INDIANA DEPARTMENT OF TRANSPORTATION

APPROVED MINUTES

February 17, 2011 Standards Committee Meeting

RE: Minutes for the February 17, 2011 Standards Committee Meeting

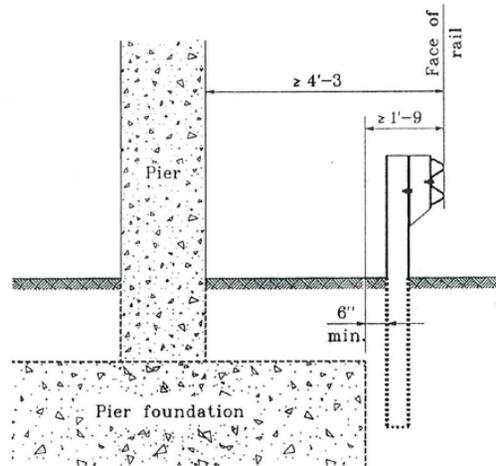
DELETE DWG. DUPLICATES EXISTING 601-MPPG-02.

601-BAGR-01 ROADSIDE BRIDGE APPROACH GUARDRAIL

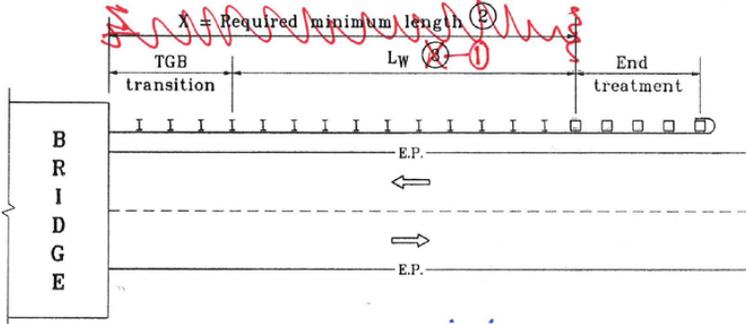
- DESIGN-RELATED** (circled in red)
- 1-X** See alternate placement detail on Standard Drawing E 601-GRET-07 for alternate placement detail.
- 2-X** L_w = length of W-beam guardrail at 6'-3" post spacing, ft. **required** **shown on plans**
- 3-X** Transition rail as required for MS unit. **end treatment**
- Guardrail will only be required when there is a hazard to be shielded** **shown on plans**
- GRBA-02** **601-001**
- TO NEW-IDM FIG. 49-4E(10)** (circled in red)

Figure 49-9A

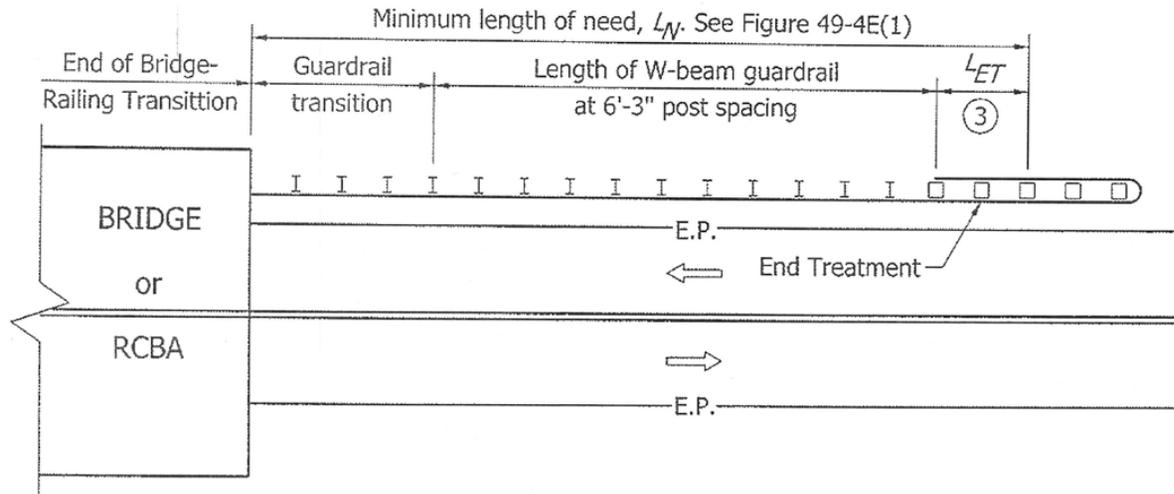
DELETE, AS TABLE DATA RESEMBLE,
SO ARE THEREFORE SUPERSEDED,
BY DATA IN NEW FIG 49-4E(1)

601-MPPG-01 MEDIAN PIER PROTECTION GUARDRAIL

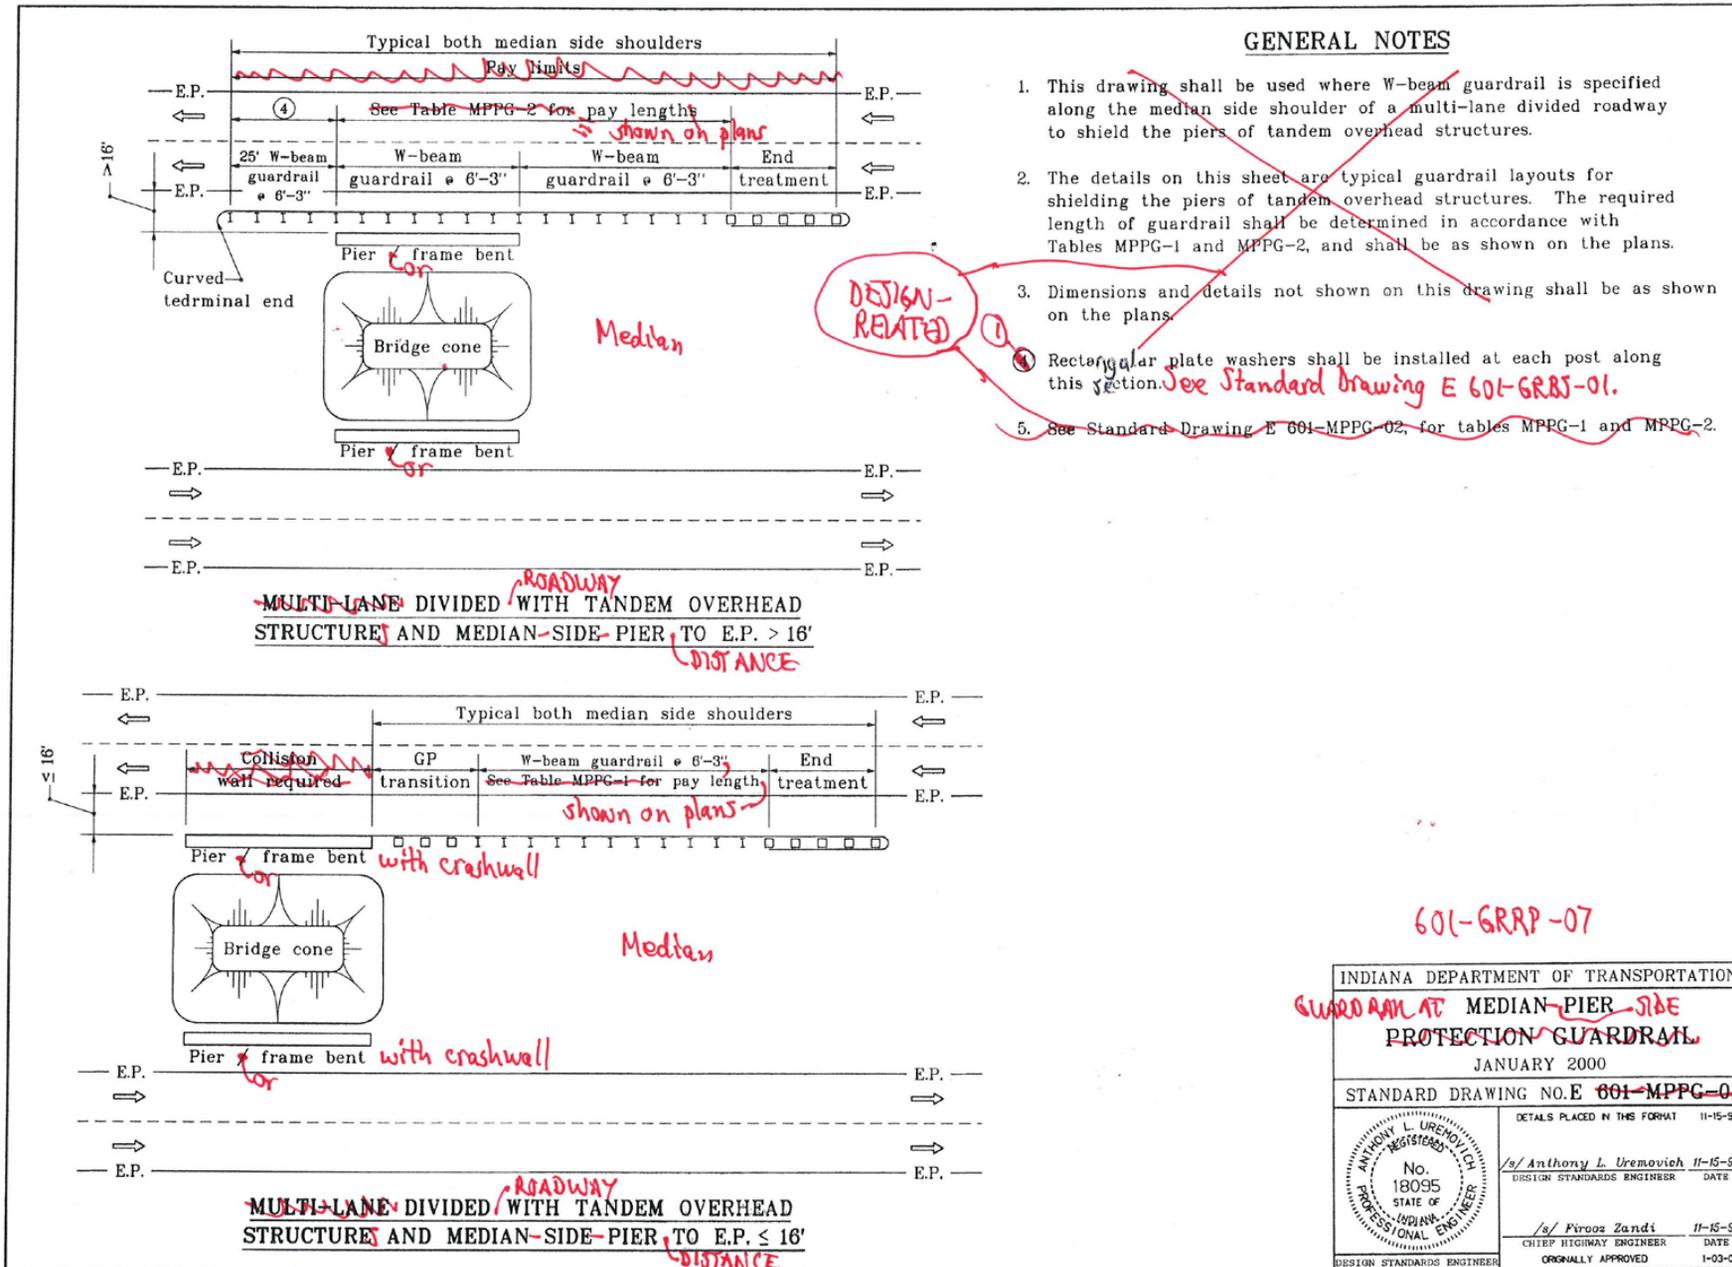
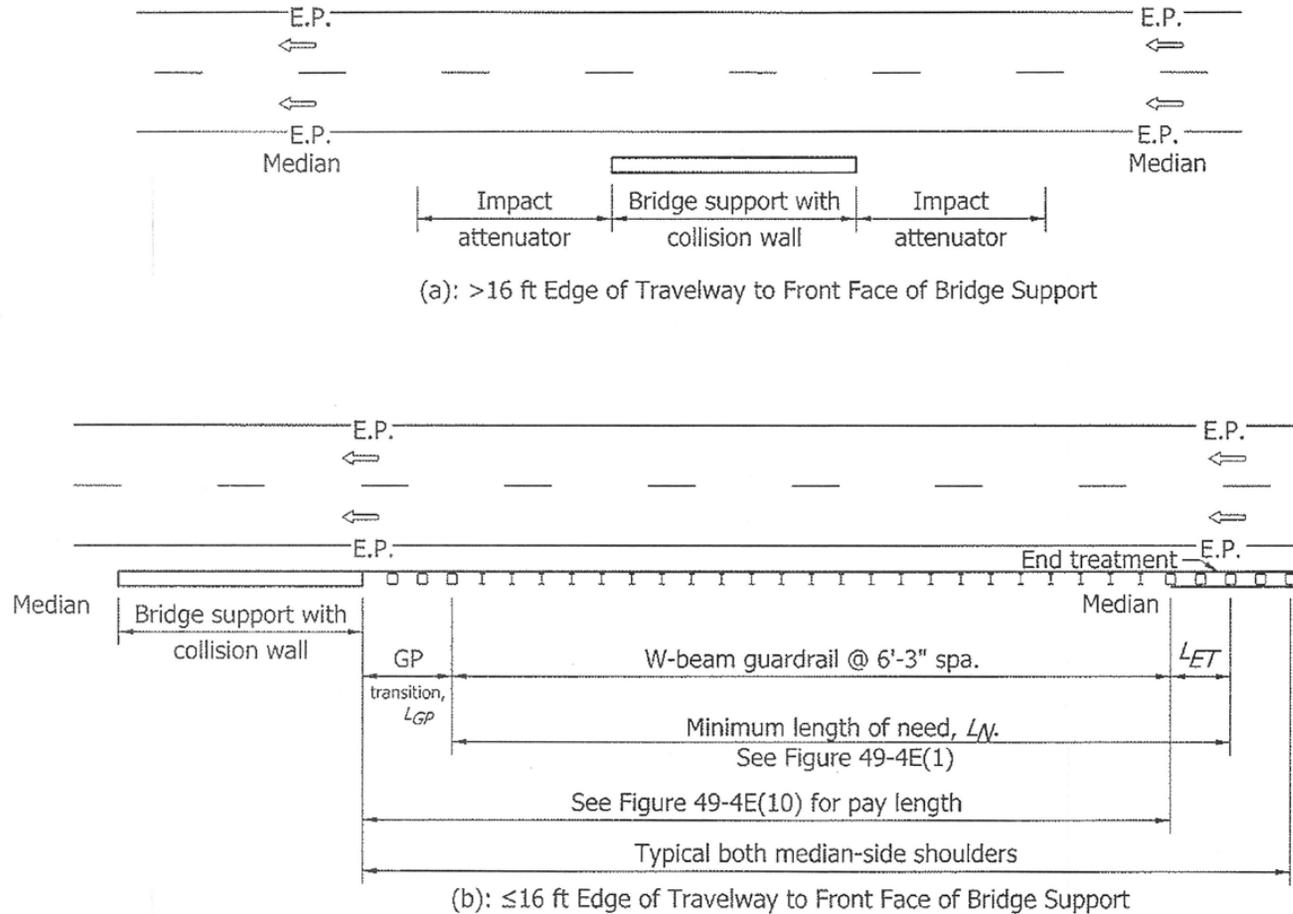
BACKUP: IDM FIGURE 49-4E(8) GUARDRAIL CONFIGURATION FOR BRIDGE SUPPORT INSIDE CLEAR ZONE, ONE-WAY ROADWAY, SINGLE OVERHEAD STRUCTURE, MEDIAN SHOULDER (DRAFT)

REVISION TO STANDARD DRAWINGS

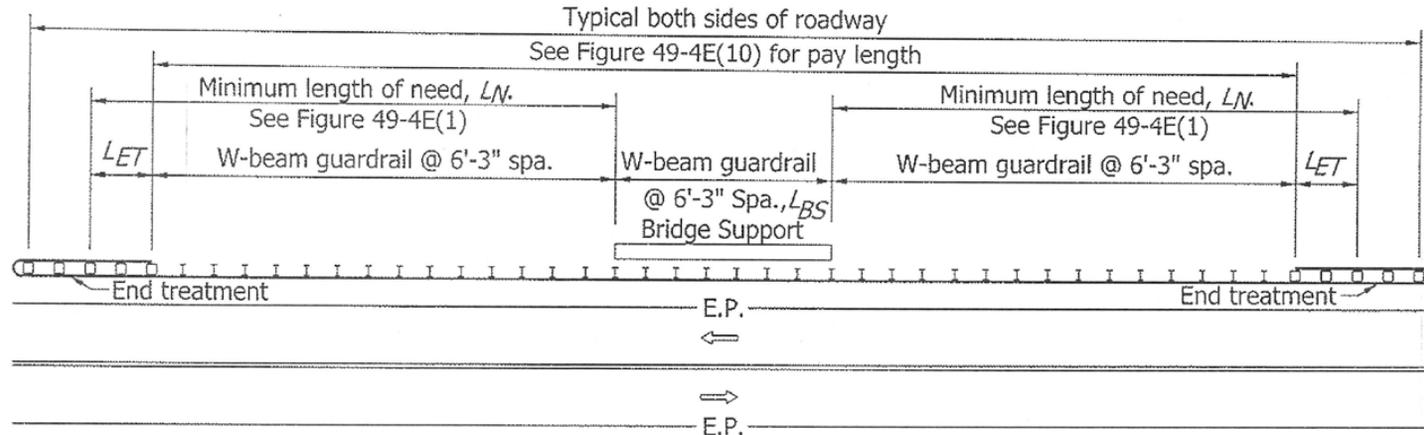
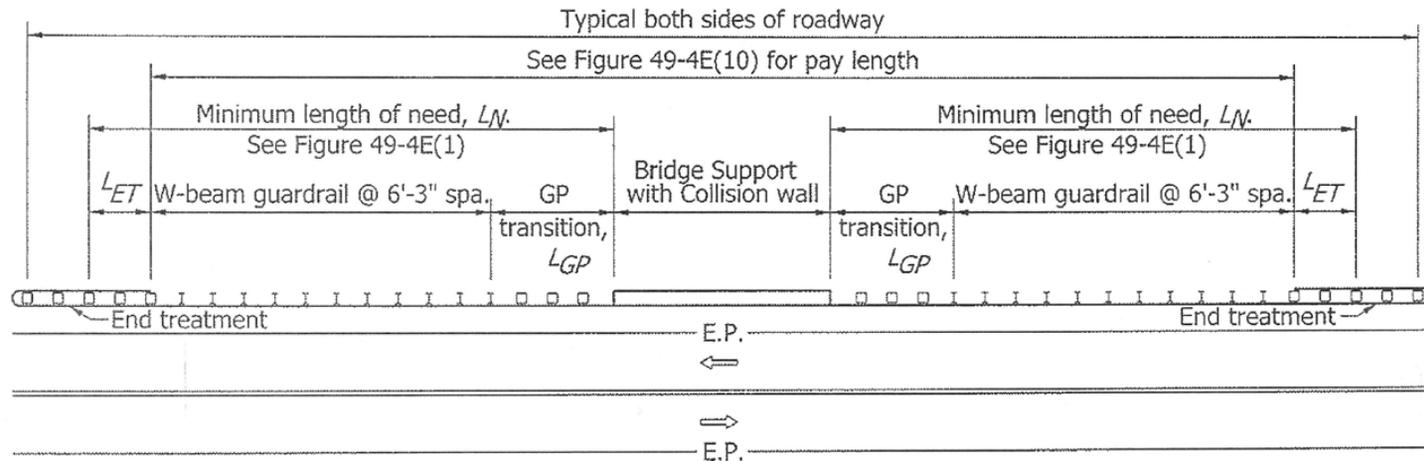
BACKUP: IDM FIGURE 49-4E(4) GUARDRAIL CONFIGURATION FOR BRIDGE SUPPORT INSIDE CLEAR ZONE, TWO-WAY ROADWAY, SINGLE OVERHEAD STRUCTURE (DRAFT)

REVISION TO STANDARD DRAWINGS

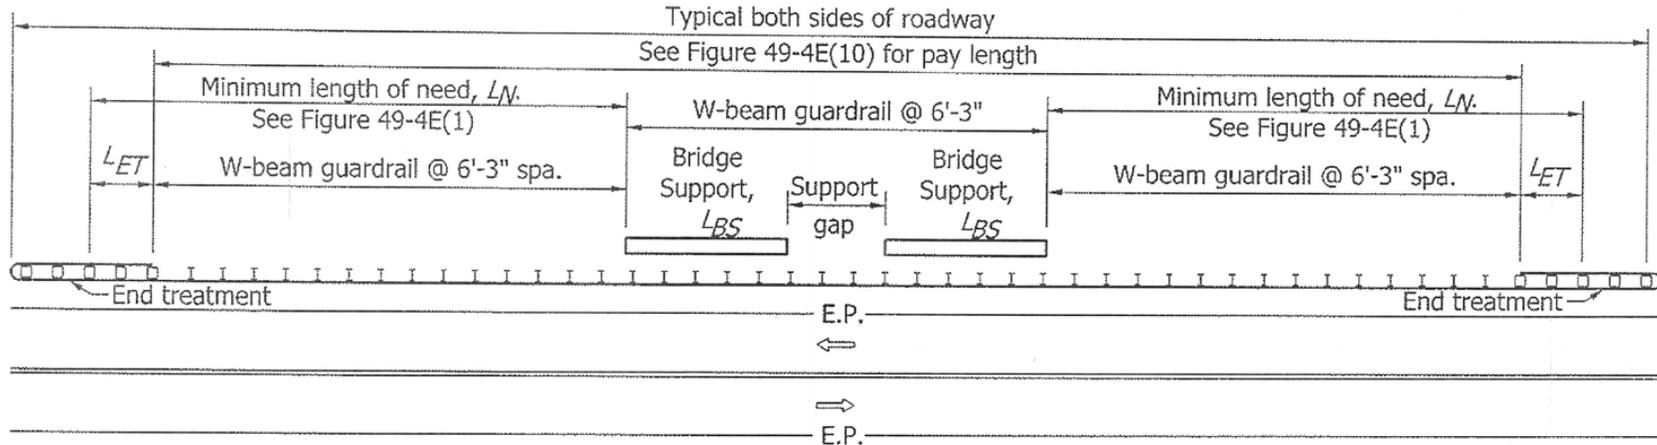
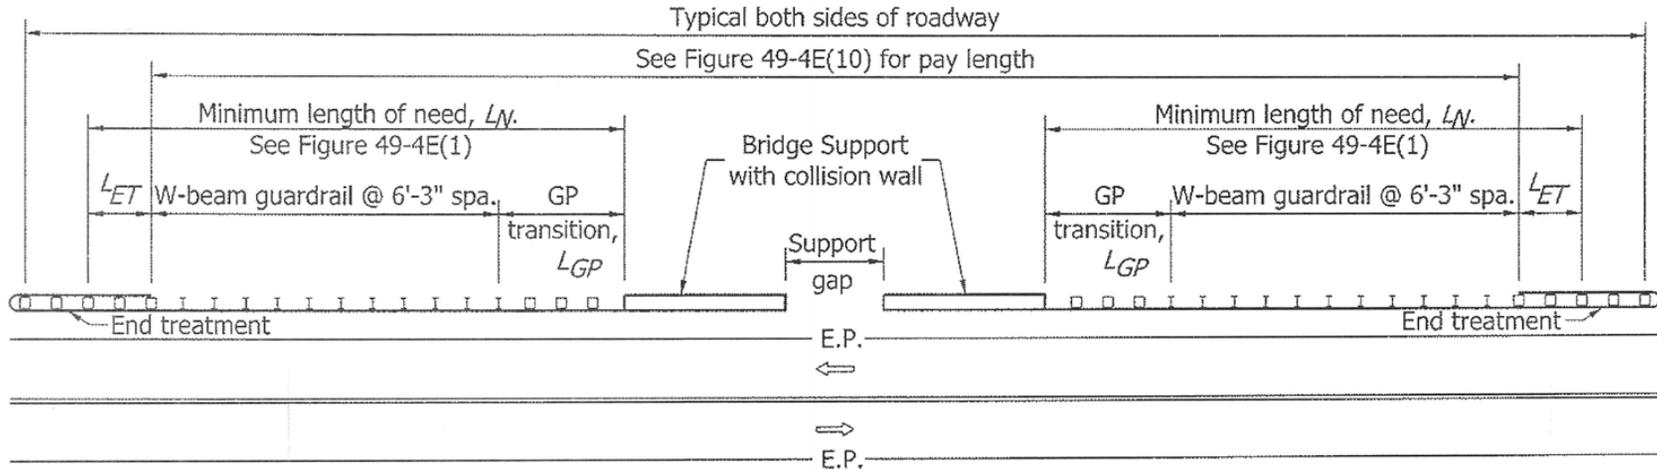
BACKUP: IDM FIGURE 49-4E(5) GUARDRAIL CONFIGURATION FOR BRIDGE SUPPORT INSIDE CLEAR ZONE, TWO-WAY ROADWAY, TWIN OVERHEAD STRUCTURE (DRAFT)

REVISION TO STANDARD DRAWINGS

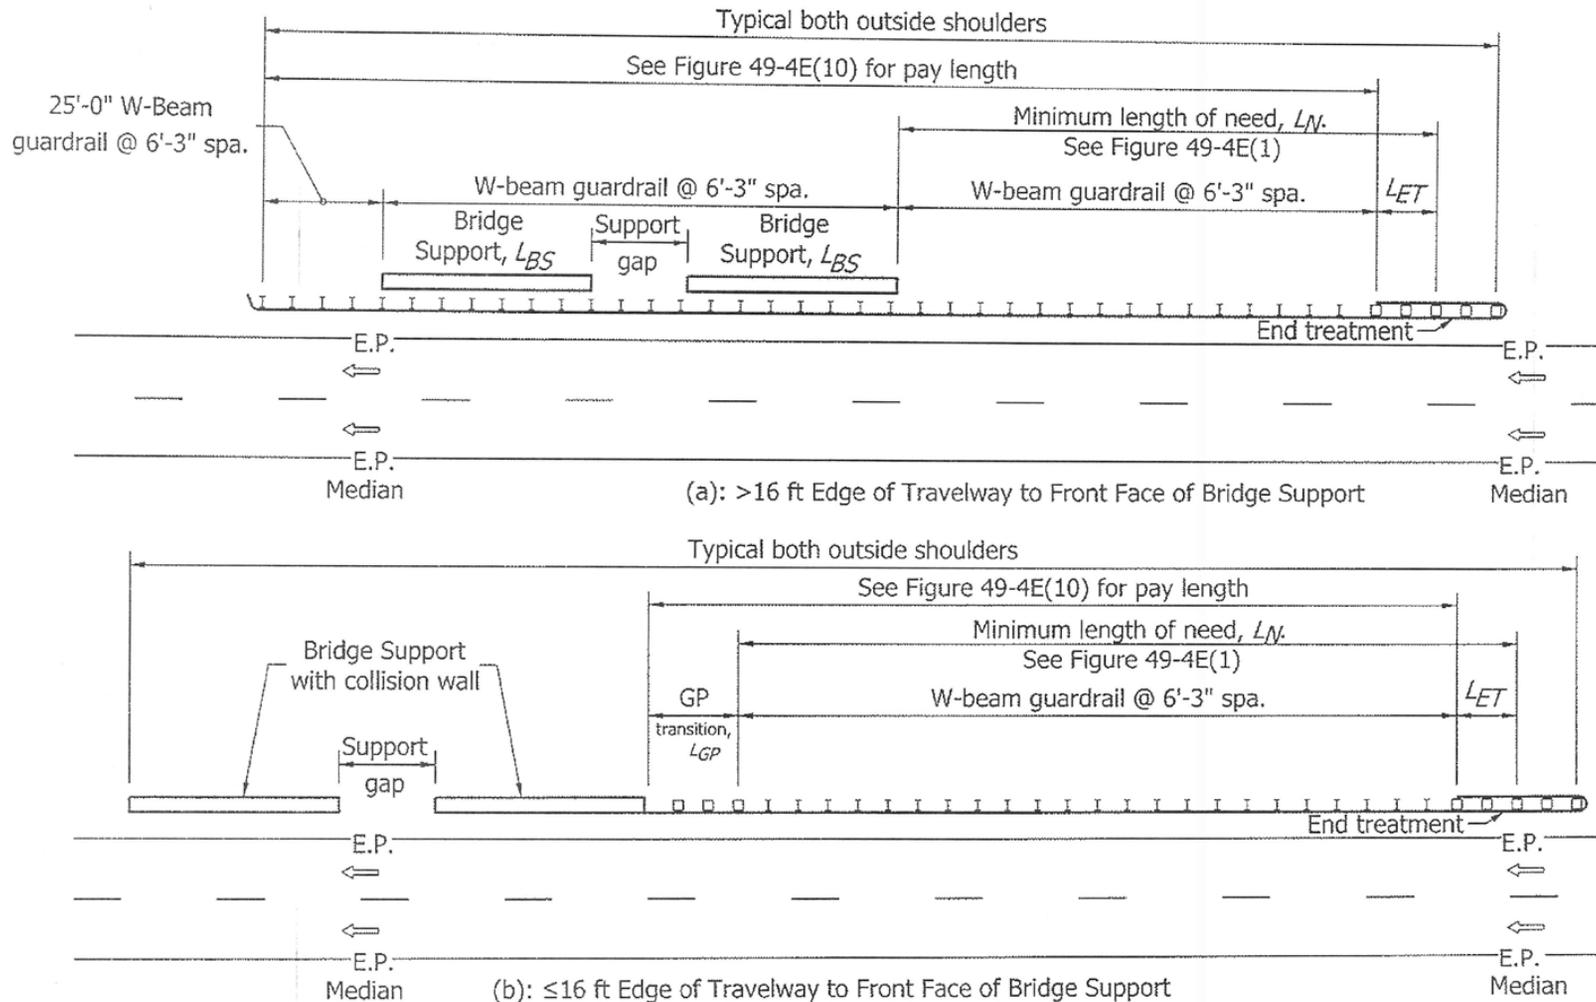
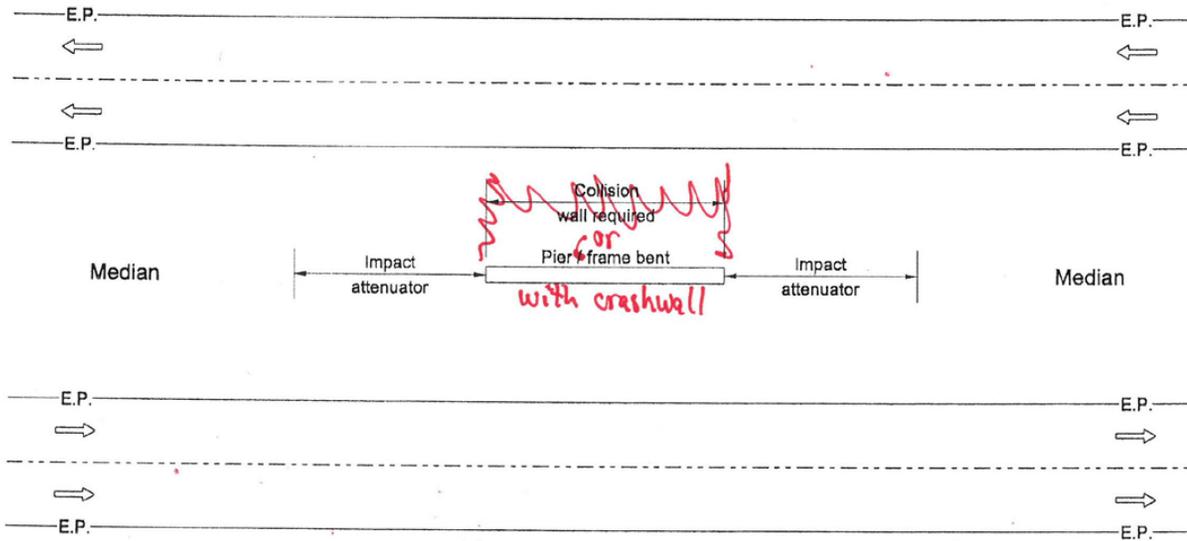
BACKUP: IDM FIGURE 49-4E(7) GUARDRAIL CONFIGURATION FOR BRIDGE SUPPORT INSIDE CLEAR ZONE, ONE-WAY ROADWAY, TWIN OVERHEAD STRUCTURE, OUTSIDE SHOULDER (DRAFT)
